Technical Bulletin

Section Title: Engine
 TSB No. TS 12 12177R

SUBJECT: P0133 (FRONT OXYGEN SENSOR SLOW RESPONSE)
MODEL(S): FORENZA, FORENZA WAGON, RENO (RQ420)
YEAR: 2006~2007
REVISION: O2 SENSOR INSPECTION AND REPLACEMENT IS ELIMINATED FROM PROCEDURE. NEW SOFTWARE TO ADDRESS CONCERN IS AVAILABLE

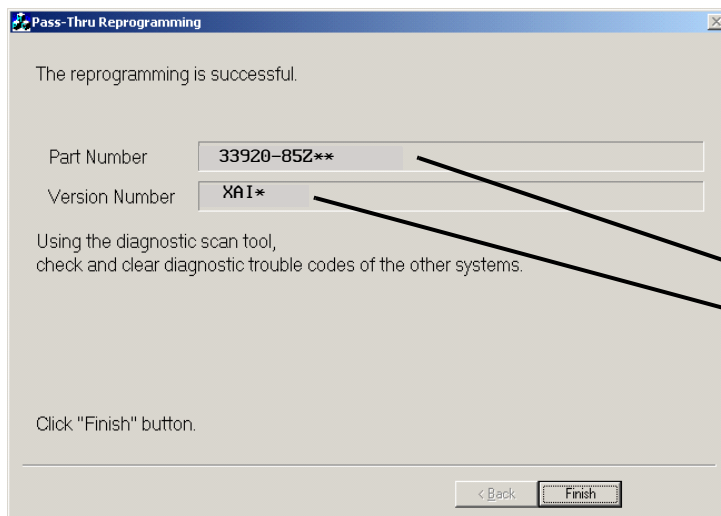
6. Fill out the Reprogram Label P/N 99963-01501-224 (the part number and version will be displayed at the "The reprogramming is successful" screen). Then affix the label to the back of the glove box door as pictured below.
7. Perform the idle relearn after reprogramming as follows.
 - a. Turn the ignition ON.
 - b. Turn the ignition OFF for 15 seconds.
